DOUGLAS, SUTTON & UXBRIDGE PLANNING BOARDS

Meeting Minutes

March 11, 2021

Joint Town Planning Board

WEST ELEVATION

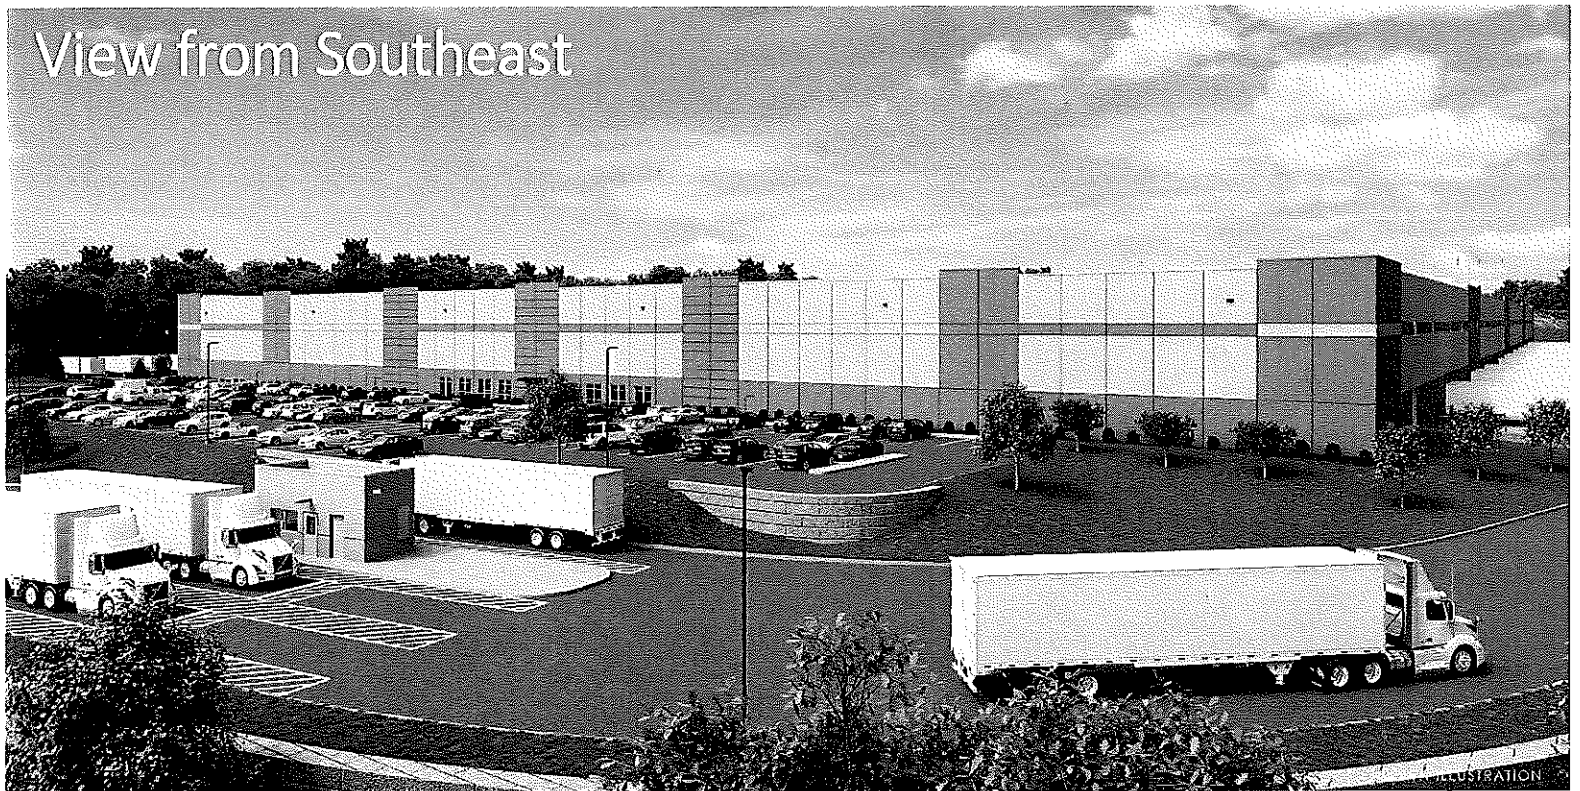
Z. Zweifler presented the architectural presentation (attached) Highlights included that not knowing who the tenant will be they intend to construct a completely empty structure with 30,000 allocated to potential office space, the structure will be 45' and docks along the west and east elevations will actually be constructed 4' below floor/ground level to allow trucks to back right to floor level. The building will be constructed of solid concrete masonry and painted in varying shades of earth tones and a number of reveals to reduce massing. There is glass in the area of offices for variation in detail and light. He reviewed an aerial and various viewshed renderings.

J. Hager, Sutton Planning Director noted the color scheme is very good but the front architecture needs work, perhaps pulling the office section forward and/or more depth or character on the front of the building to avoid just a HUGE rectangle with no character. There also needs to be a lot more landscaping along Lackey Dam Road. She noted there will always be a condition to ensure intended landscaping screening is achieved.

M. Gallerani echoed J. Hager's comments, noting the office should bump out at least slightly and there should be architecture or features that pay tribute to the Blackstone Valley and makes what the neighborhood sees more aesthetic.

View from Lackey Dam Road (Northbound)

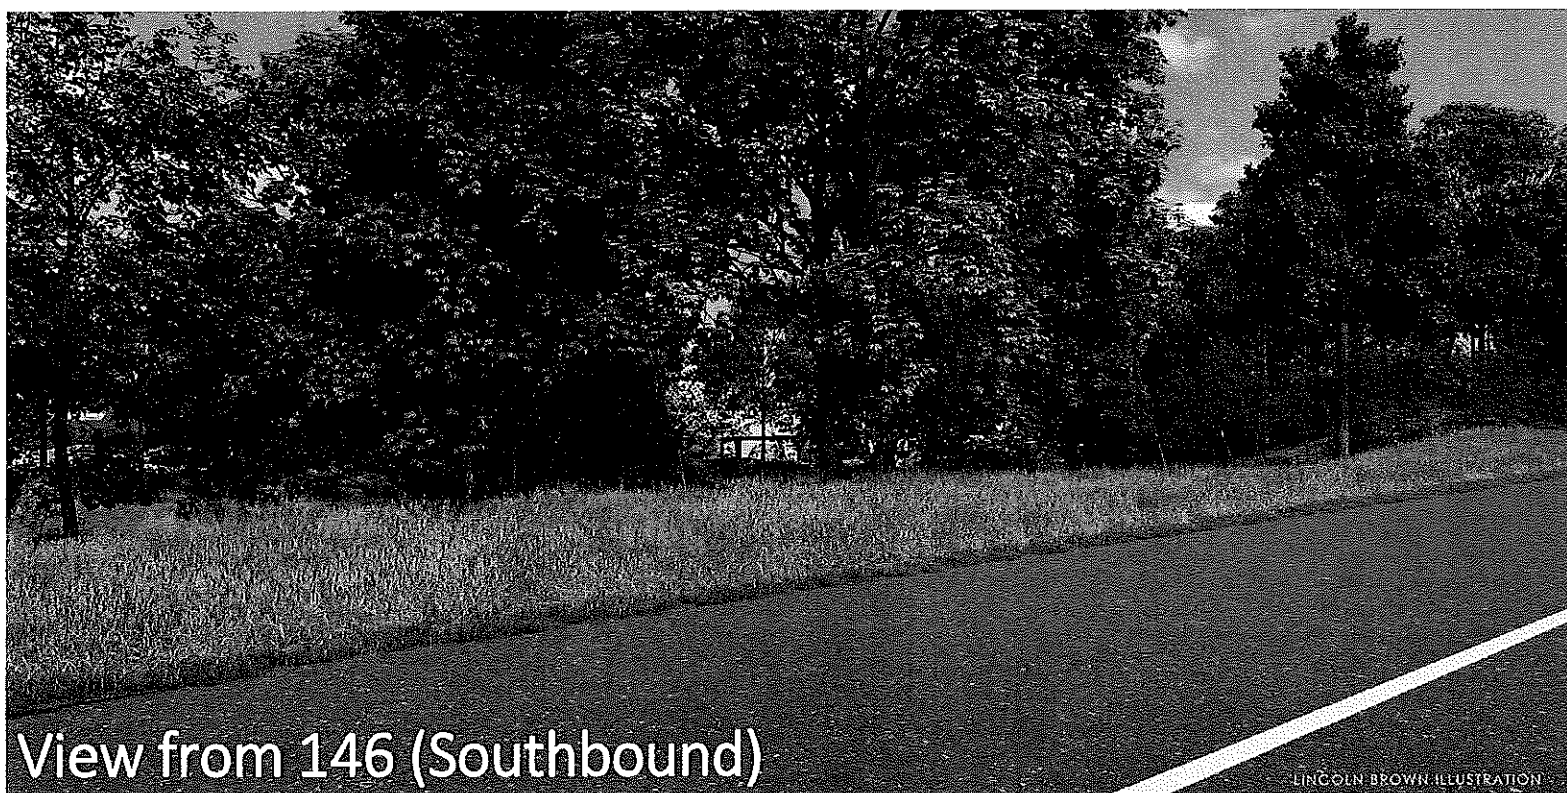
E. Laverdiere wants to see the views from both directions on Lackey Dam Road. He stated he expects to see significant landscaping to help these residents.

J. Walsh reinforced headlight impact should be evaluated perhaps by providing cross sections and if there is a problem creating a "backstop" to block glare. With respect to view to Lackey Dam Road they also need to take into consideration the elevation change.
